Base Load Power Hub (BLPH)

90% 3D Model Review Report

Document Number: 123A90-DDL-PP-RE-70010

BLPH - 90% 3D MODEL REVIEW
ACTION ITEM REGISTER

MR90-TAG01

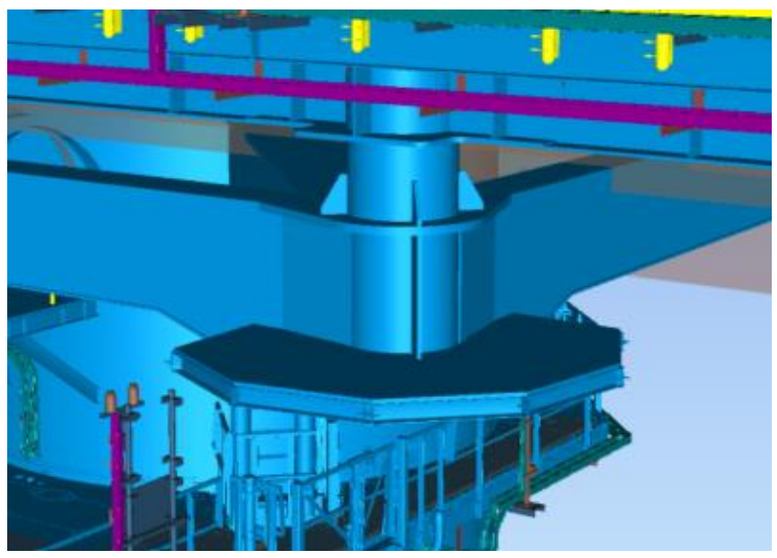
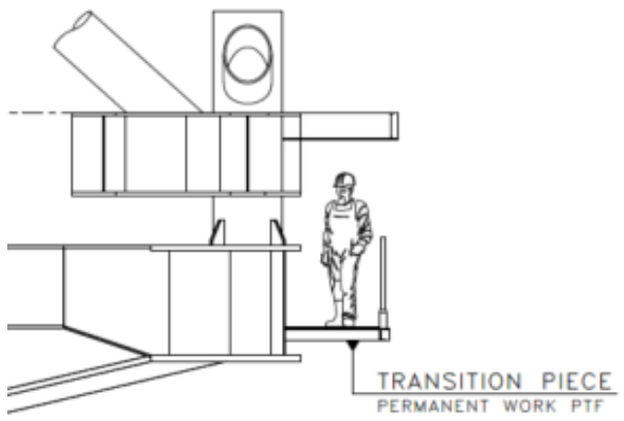
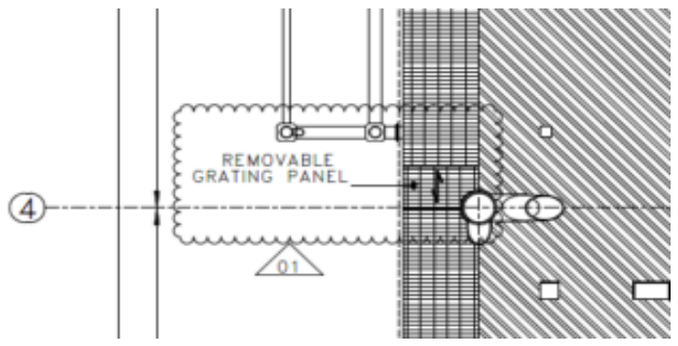
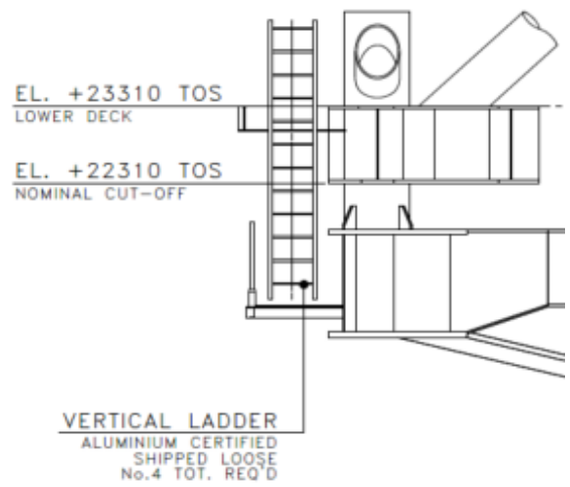
Temporary ladder from lower deck to TP to be shown plus installation aids

Removable panels in LD are indicated in doc. n. 123A90-DDL-ST-DD-90059. Vertical connection will be provided by alluminium certified ladders shipped loose and secured with cargo strap on topside. No additional installation aids are foreseen since on TP all workplatform are permanently welded
(ref. doc. 123A90-DDL-TI-DD-99043)

MR90-TAG02

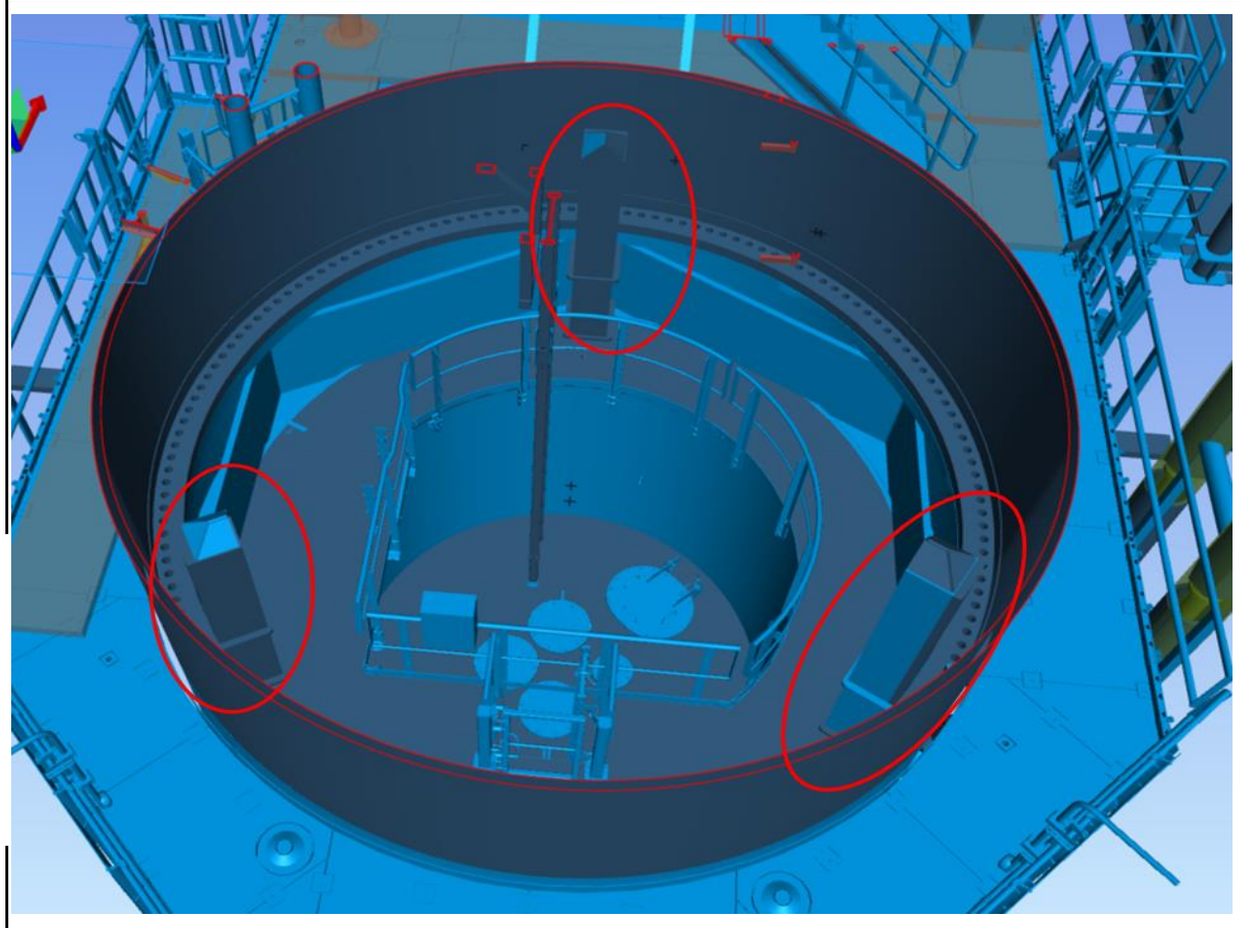
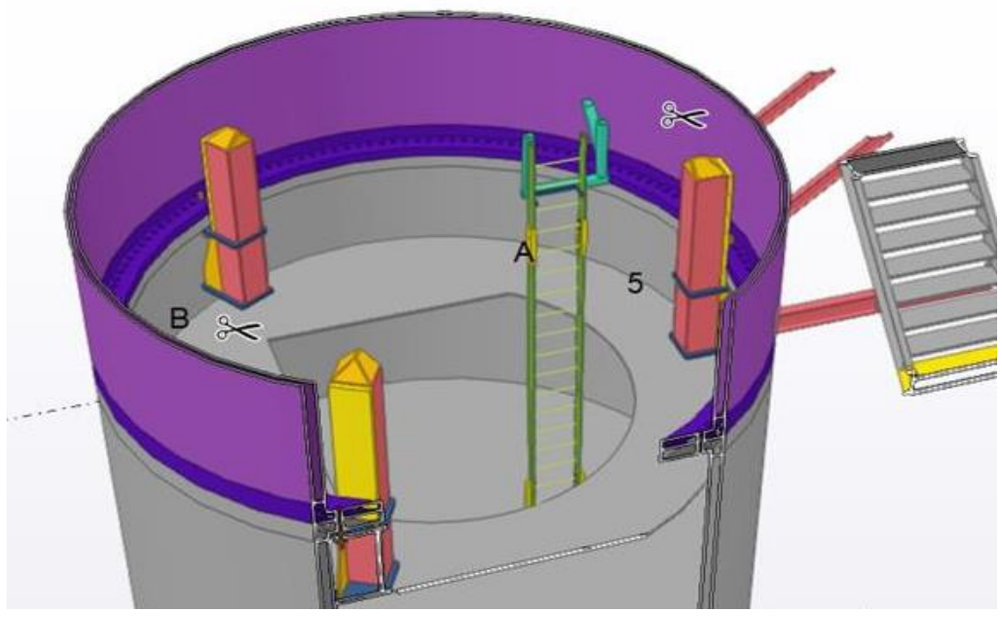
Temporary installations aids to be shown

Temporary installation AIDS have been shown

MR90-TAG03

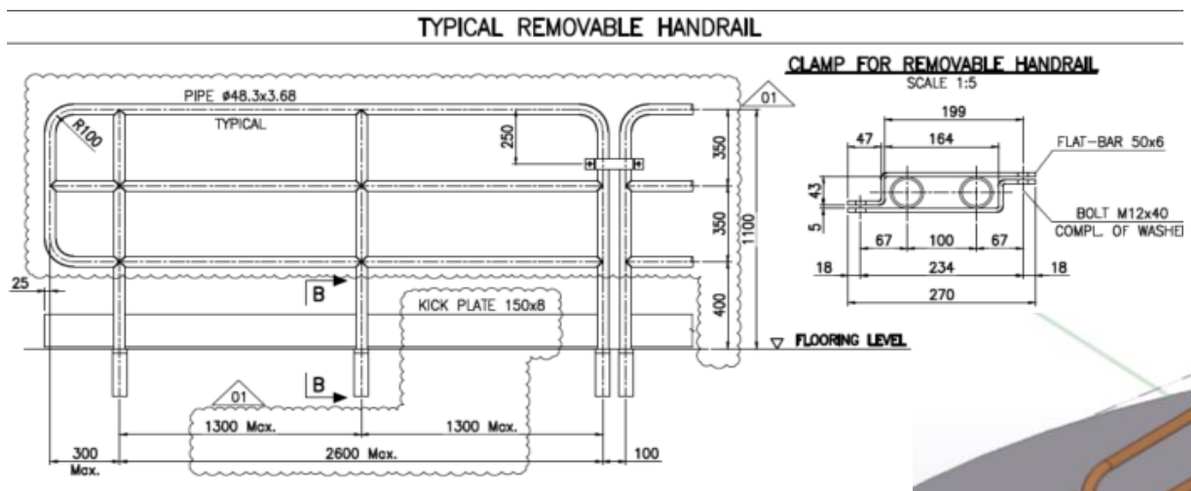
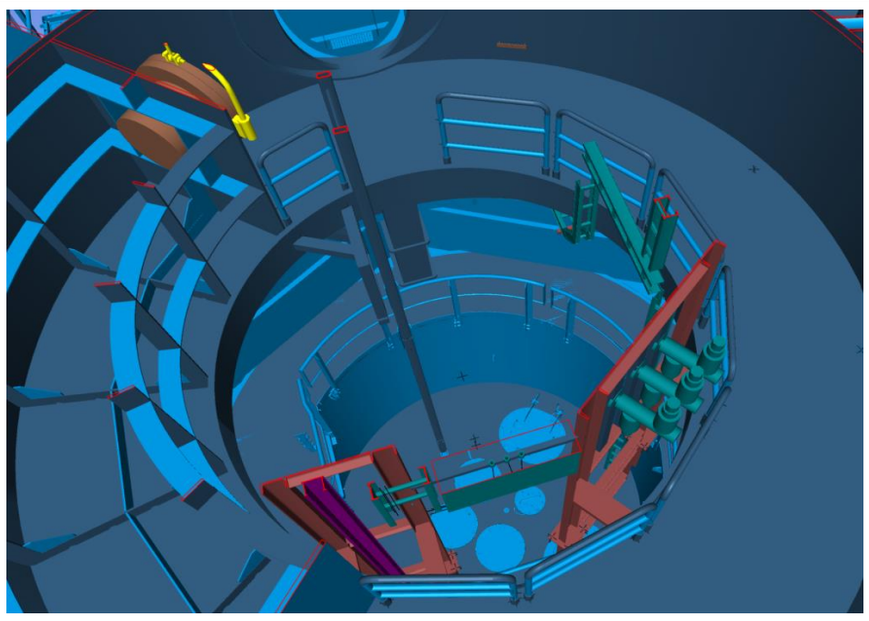
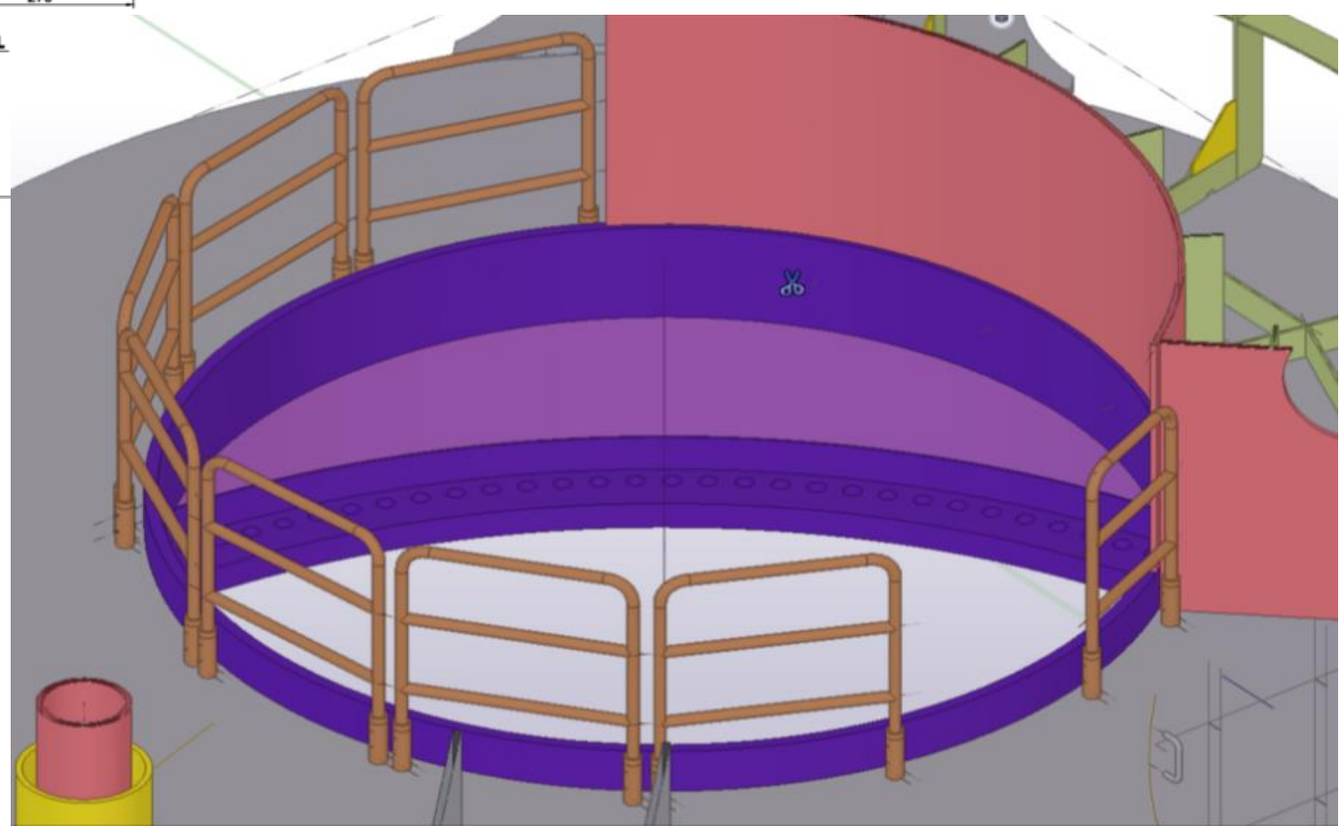
Removable handrail to be shown

All handrails in TP ring are removable as per doc. n 123A90-DDL-ST-DD-90037

MR90-TAG04

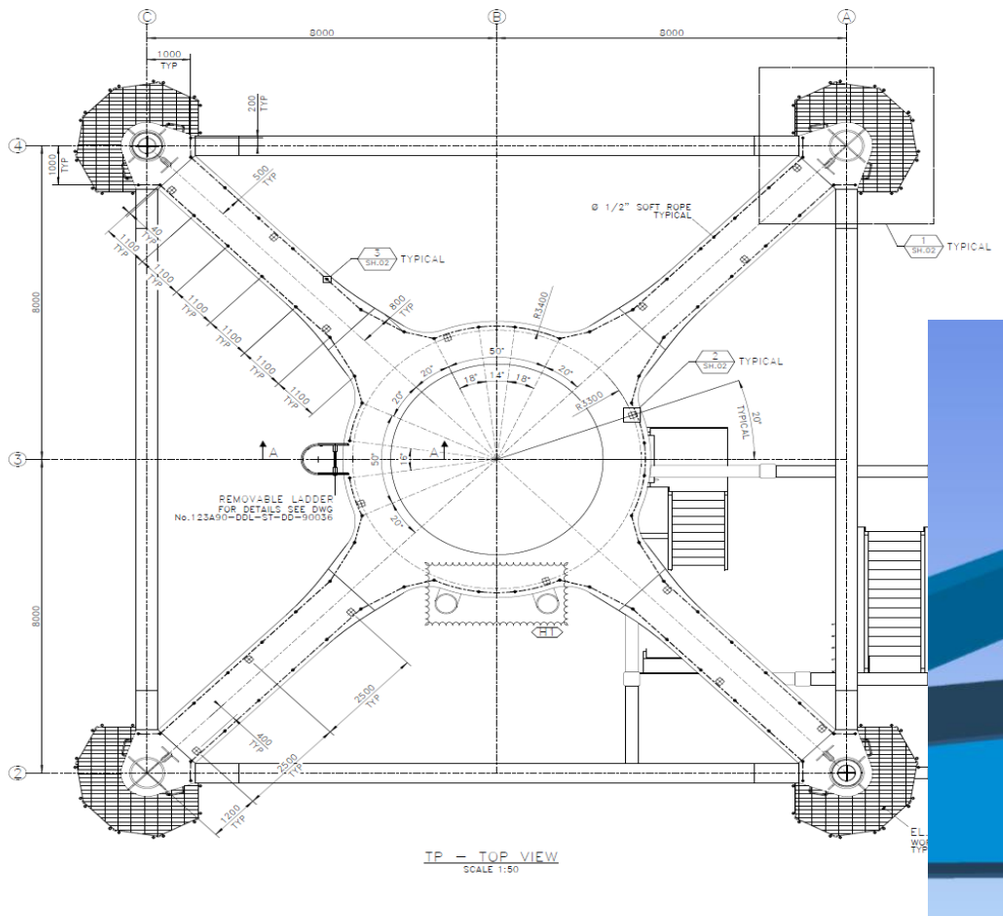
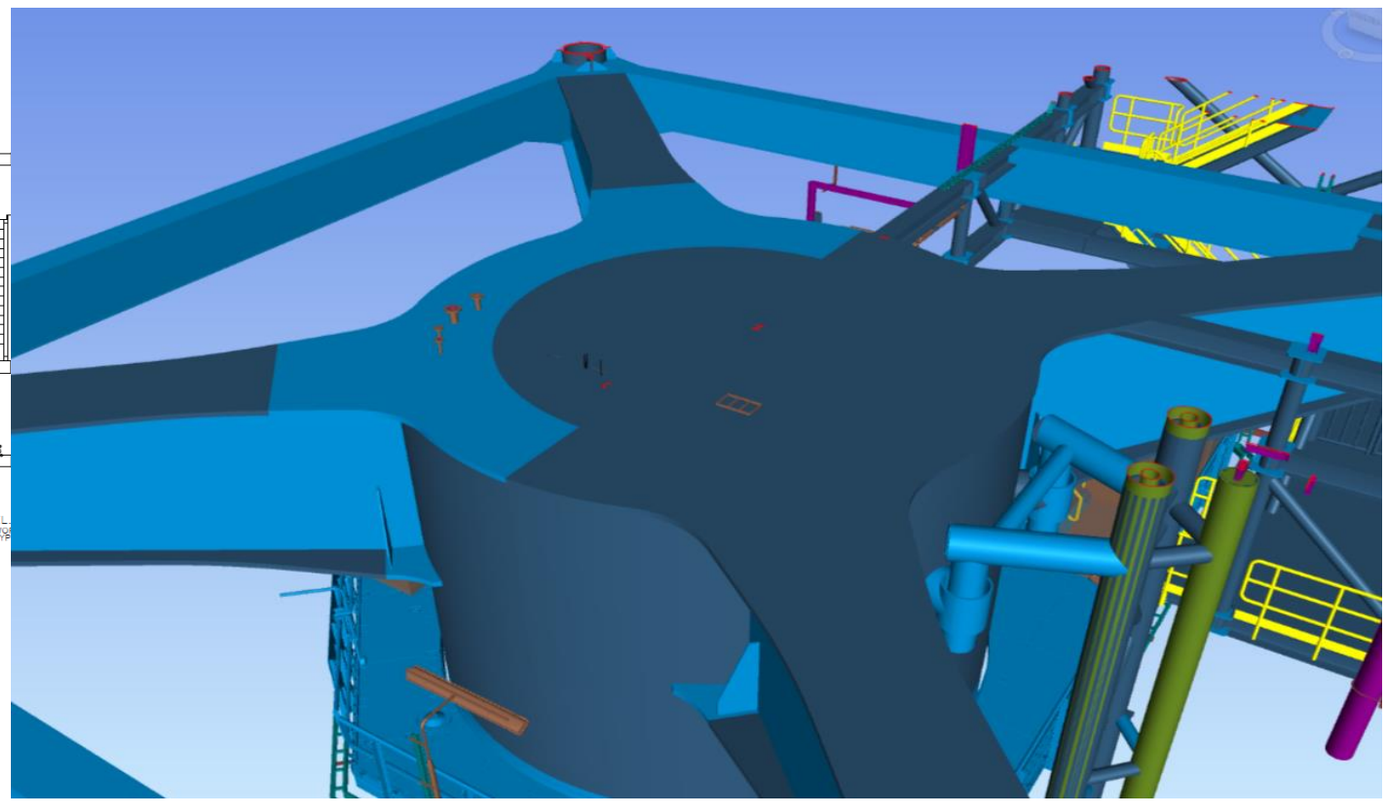
Hook-up activities to be discussed with CPY

Top of TP will be free of any obstacle, redy to use during installation campaign. Refer to drawing 99043. the only items present will be proteted by phisical barrier (wooden piece) and clearly identified (e.g. n.4 valves)

MR90-TAG05

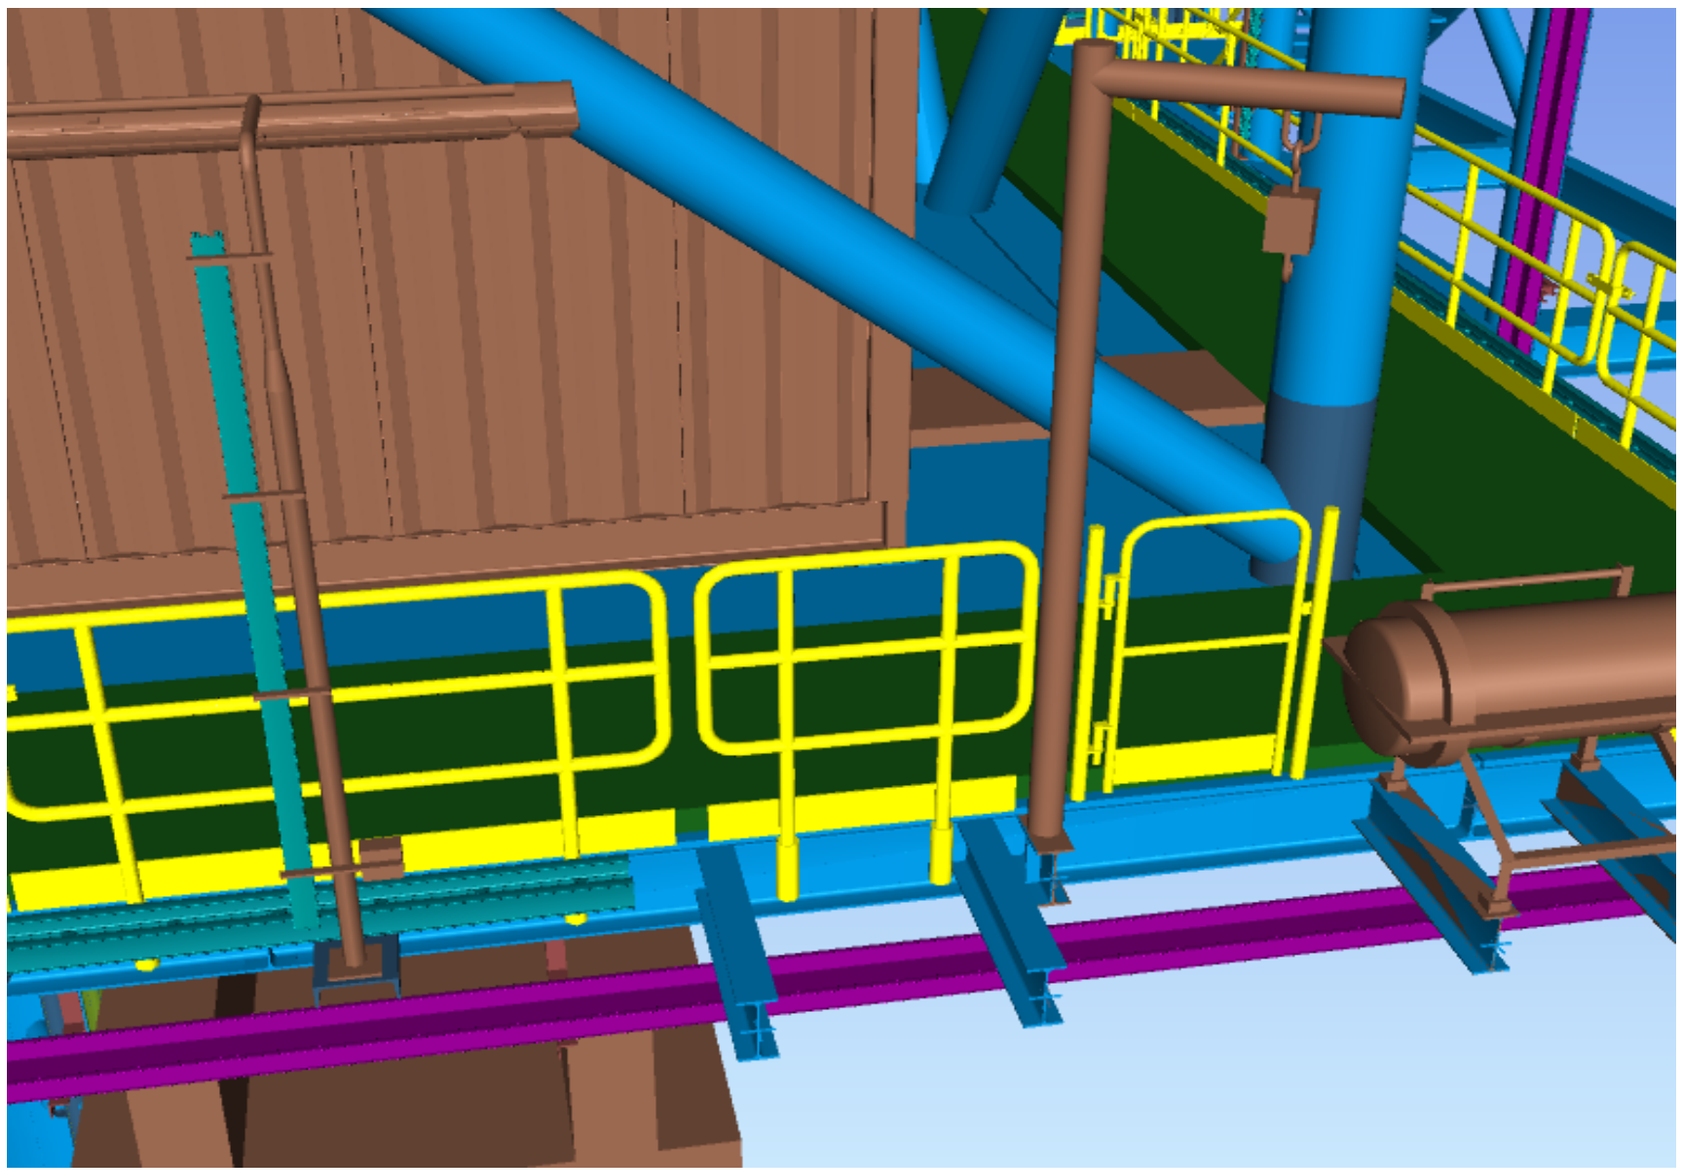
To put the handrail

Added a new handrail

MR90-TAG06

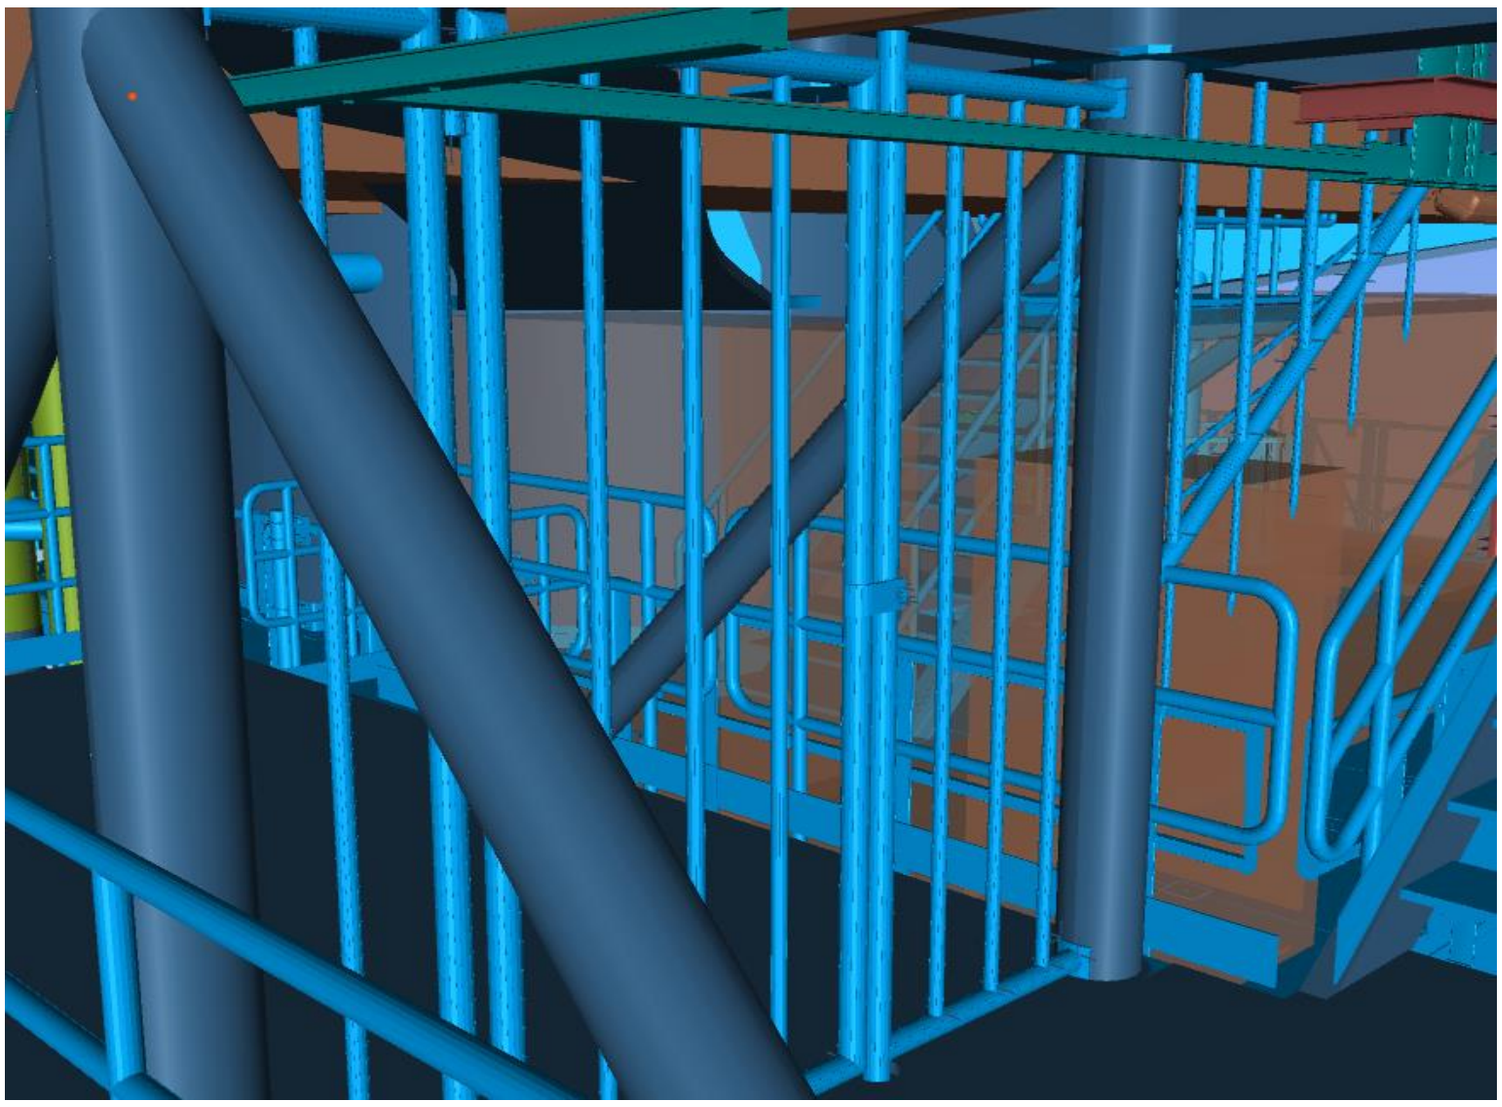
To discuss anti intrusion barrier

The topic has been already closed in October, please refer to the close-out sheet which is part of the latest HAZID close-out update (123A90-DDL-SAF-RE-30010 issued by Rosetti)
